**REVIEW OF APPLICATION FOR LIHI CERTIFICATION  
OF THE  
CHICOPEE FALLS HYDROELECTRIC PROJECT**

**FERC No. P-6522, exempt  
Chicopee River, Massachusetts**

**May 20, 2026  
Maryalice Fischer, Certification Program Director**

Figure 2. Key Project Features

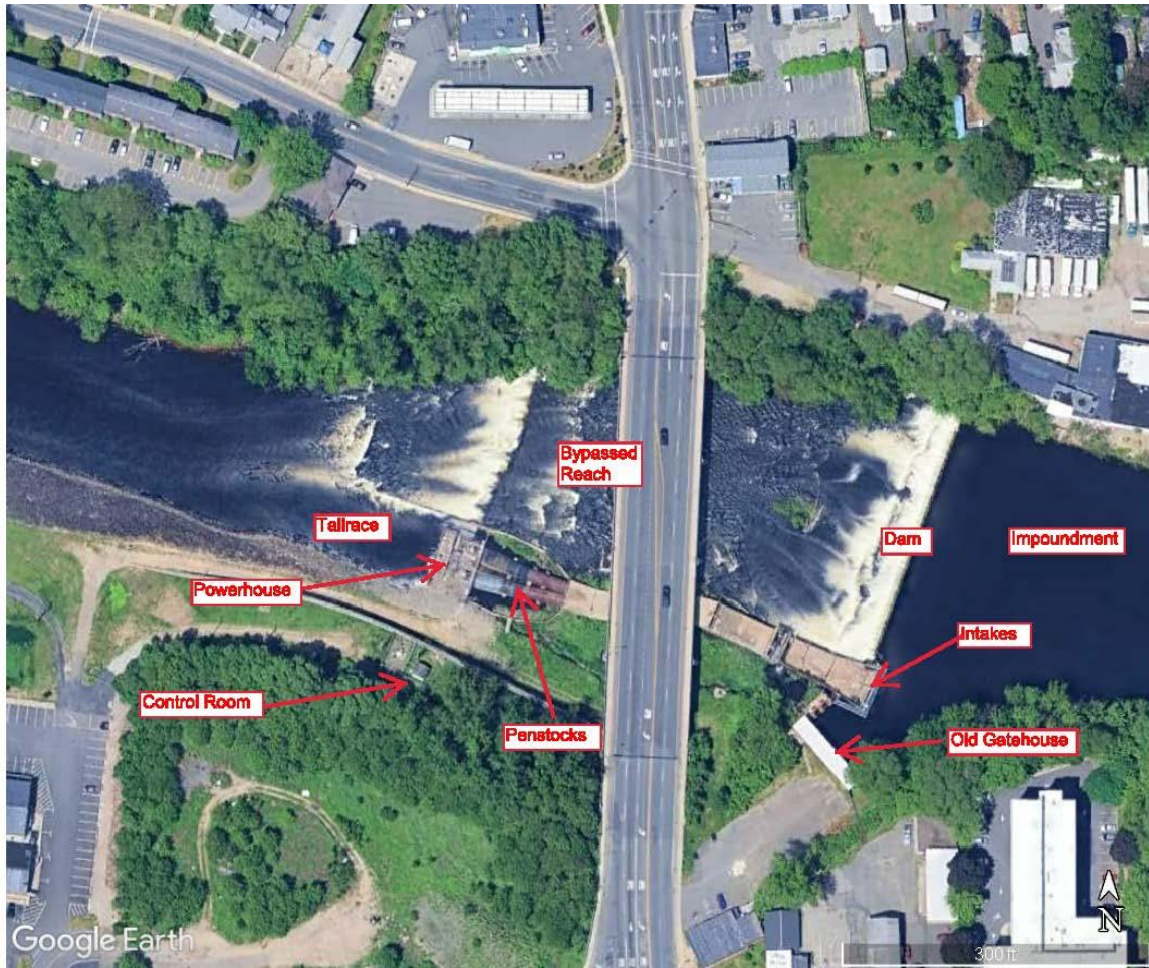
<sup>1</sup> Some parts of the LIHI application mis-state the flashboard height as 1.5 ft, and the dam length as 314 ft (which includes the non-spillway portions).

<sup>2</sup> The LIHI application incorrectly listed the turbines as a 1,700-kW unit and an 800-kW unit.
